**PLANNED UNIT DEVELOPMENT  
& SUBDIVISION STAFF REPORT****Date: December 7, 2006**

<b><u>DEVELOPMENT NAME</u></b>	American Tennis Courts Subdivision
<b><u>SUBDIVISION NAME</u></b>	American Tennis Courts Subdivision
<b><u>LOCATION</u></b>	West side of Bolton's Branch Drive, 620' ± South of Halls Mill Road
<b><u>CITY COUNCIL DISTRICT</u></b>	District 4
<b><u>PRESENT ZONING</u></b>	B-3, Community Business District
<b><u>AREA OF PROPERTY</u></b>	1 Lot / 1.4 ± acres
<b><u>CONTEMPLATED USE</u></b>	Planned Unit Development approval to allow an office/warehouse building, above-ground fuel tanks, and four containerized storage units on a single building site, and Subdivision approval to combine two lots into one lot.
<b><u>TIME SCHEDULE FOR DEVELOPMENT</u></b>	Immediate
<b><u>ENGINEERING COMMENTS</u></b>	Must comply with all storm water and flood control ordinances. Any work performed in the right of way will require a right of way permit.
<b><u>TRAFFIC ENGINEERING COMMENTS</u></b>	Driveway number, sizes, location and design to be approved by Traffic Engineering and conform to AASHTO standards.

# SITE PLAN

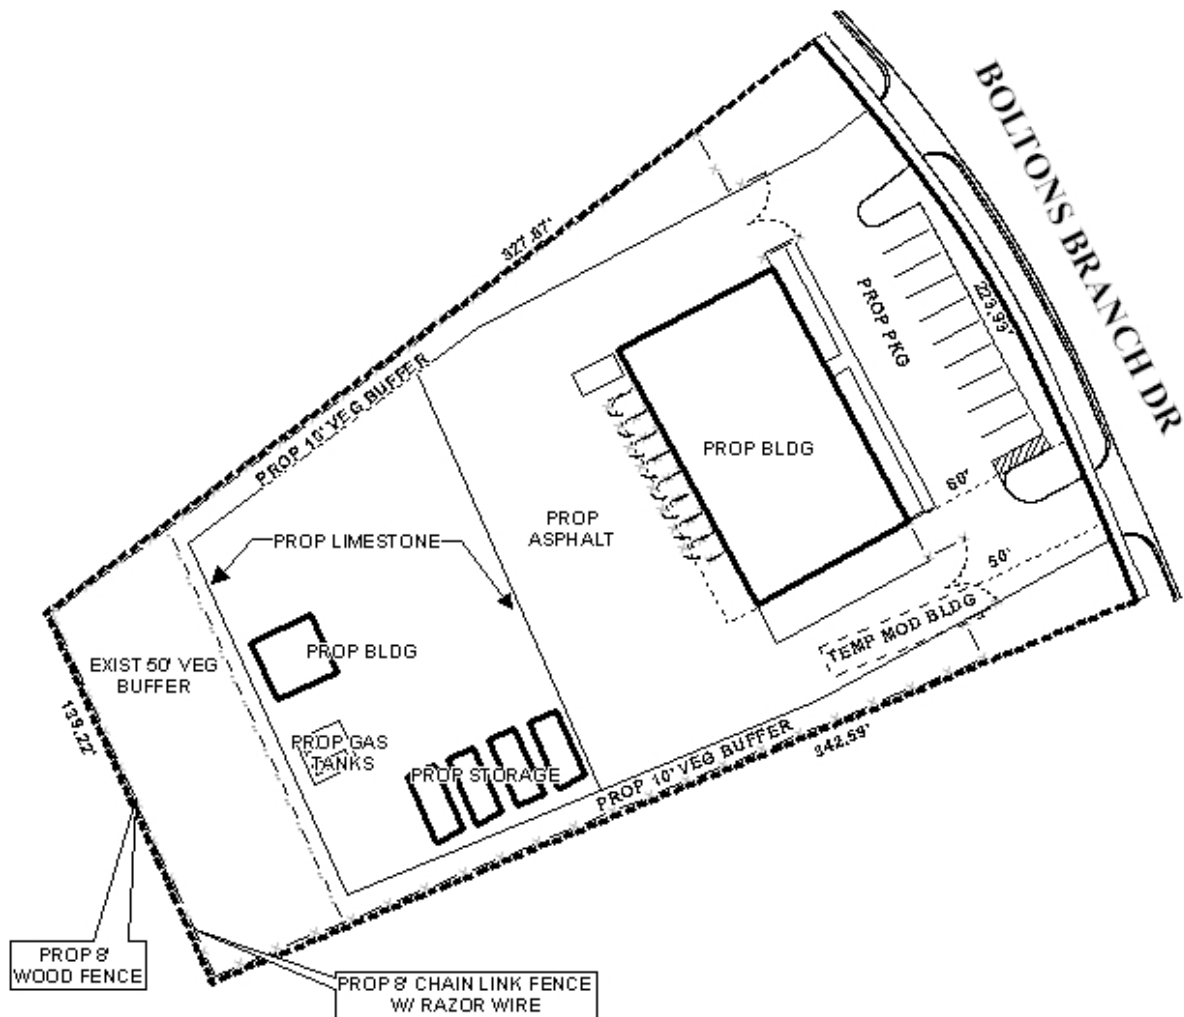
The 25-foot minimum building setback line, required in Section V.D.9. of the Subdivision Regulations, is not shown on the subdivision plat or site plan. The plat and site plan should be revised to depict the setback line.

It appears that the site may be adequate for occasional tractor-trailer traffic, however a circulation clear area should be depicted on the PUD site plan and maintained during business operations to ensure that such traffic can circulate through the paved portion of the site. Furthermore, an increased curb turning radius may be recommended for the driveway that will act as the entry point for tractor-trailers servicing the site.

The above ground fuel storage tanks and paint mixing and storage area are proposed for the portion of the site that will be graveled, if approved by the Board of Adjustment. Two concerns come to mind, the proximity of above ground fuel tanks and paint to single

family residential uses to the West, and the gravel parking should there be a spill of fuel or paint onto the ground. It would seem that paving of the area and provision of some sort of detention for fuel leaks may be appropriate (a spill response and containment plan may be required at the state level by the Alabama Department of Environmental Management, or at the federal level). Furthermore, it would appear that the re-fueling truck would have to drive across the limestone area to reach the tanks, thus it may be appropriate to pave the bulk of the proposed gravel area. Finally, while the fuel tanks must be separated by a minimum of 50 feet from any “important” structures and property lines according to fire regulations, the proximity of such a use to adjacent single-family residential development, or any residential development, does not appear to be a desirable situation to create through the proposed planned unit development. If the above-ground storage tanks are approved by the Board of Adjustments, compliance with local, state and federal regulations will be required regarding the tanks.

A specific tree and landscaping plan has not been provided, however, full compliance with Section 64-4.E. of the Zoning Ordinance will be required. It does not appear that sufficient landscape area is provided between the building and the front property line to comply with Section 64-4.E., thus the applicant should ensure that adequate landscape area is provided.

**Subdivision:** This application is recommended for Tentative Approval, subject to the following conditions: 1) depiction of the 25-foot minimum building setback line; 2) placement of a note on the site plan and plat stating that the site is limited to a total of two curb-cuts, with the size, design and location to be approved by Traffic Engineering and conform to AASHTO standards; and 3) full compliance with all other municipal codes and ordinances.
